OH BKL ILS OR LOC RWY 24R AMDT 2

4-18-2022 PRB Results: SIGNED/COMPLETE/APPROVED

3-3-22 Returned for Rework

2-25-22 RETURNED FOR REWORK

ILS or LOC RWY 24R
BURKE LAKEFRONT (BKL)

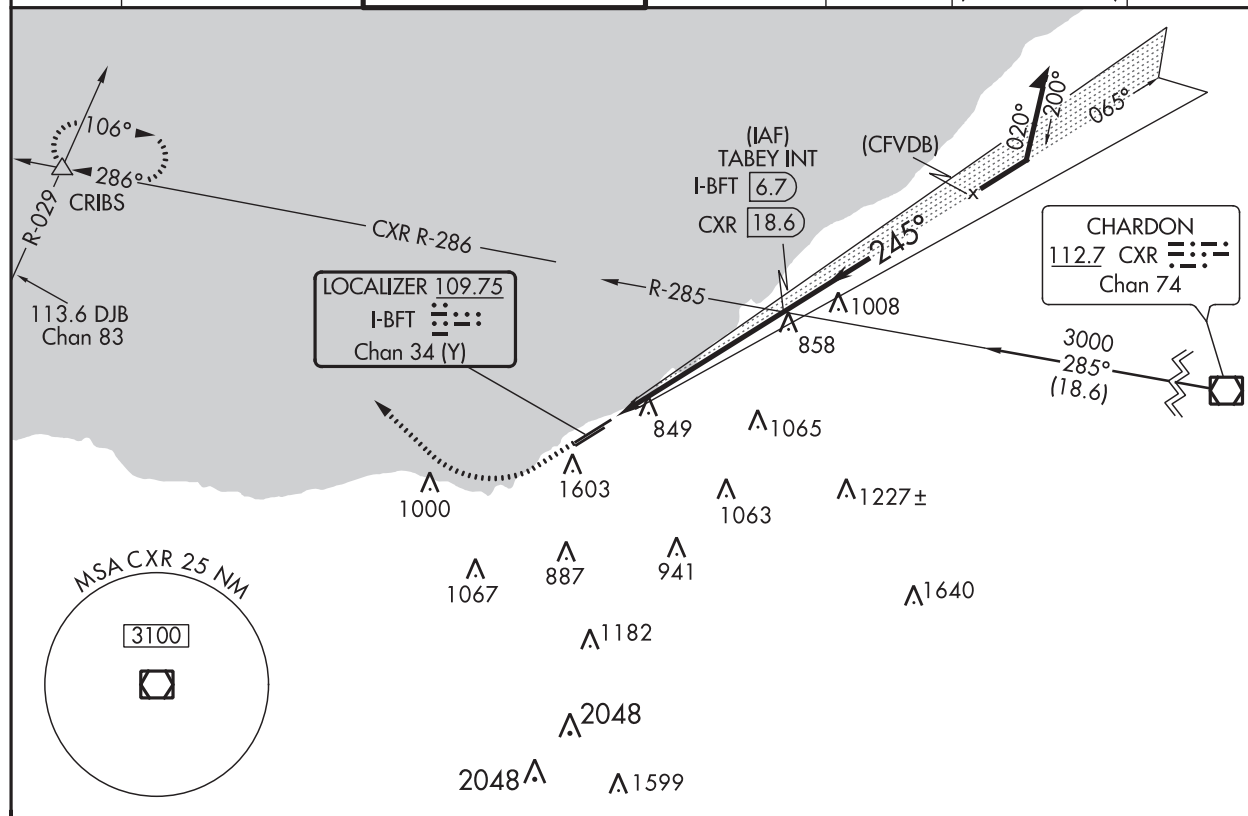
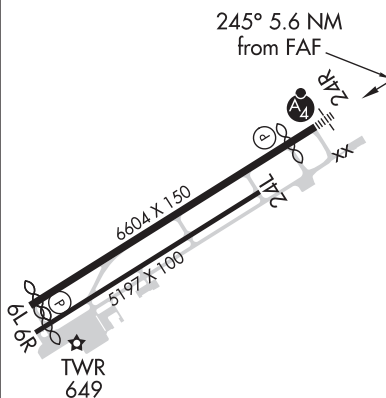
V4 IS BEING RETURNED FOR THE FOLLOWING,
AS THESE CORRECTIONS WERE NOT COMPLETE: 1. PDF PAGE 27 SHOWS AN EVALUATION THAT
DOESN'T GO OVER LLROY. BASED ON THE MISSED APPROACH INSTRUCTIONS THE EVALUATION
MUST TURN TO A 350 HEADING AND THEN INTERCEPT R-056 TO LLROY THEN CONTINUE TO NEVTE.
THE TIE-BACK ISN'T CORRECT. IT APPEARS THAT THE TARGETS BUILD IS A TURN TO NEVTE NOT TURN
TO A HEADING THEN INTERCEPT A RADIAL AND THEN VIA THAT RADIAL TO NEVTE.

V3 IS BEING RETURNED FOR THE FOLLOWING: 1) PLEASE PROVIDE AN EVALUATION OF THE MISSED APPROACH AS DEPICTED ON THE 8260 FORMS. 2) PLEASE PROVIDE CALCULATIONS FOR THE ELS. THESE CORRECTIONS WERE NOT SUBMITTED WITH THE ORIGINAL PRB RESULTS THAT WERE PREVIOUSLY SENT TO AIS, WE APOLOGIZE FOR THE ERROR.

DME required. RADAR required for procedure entry.			MALSF	MISSED APPROACH: Climb to 1120 then climbing right turn to 2000 on heading 350° to DJB VOR/DME R-056 to LLROY/DJB 25.5 DME then climb to 3000 on DJB VOR/DME R-056 to NEVTE/DJB 31.1 DME and hold.		
Circling Rwy 6R NA at night. Rwy 24R helicopter visibility reduction below ¾ SM NA. Circling NA southeast of Rwy 6R-24L. S-ILS minimums NA when control tower closed.
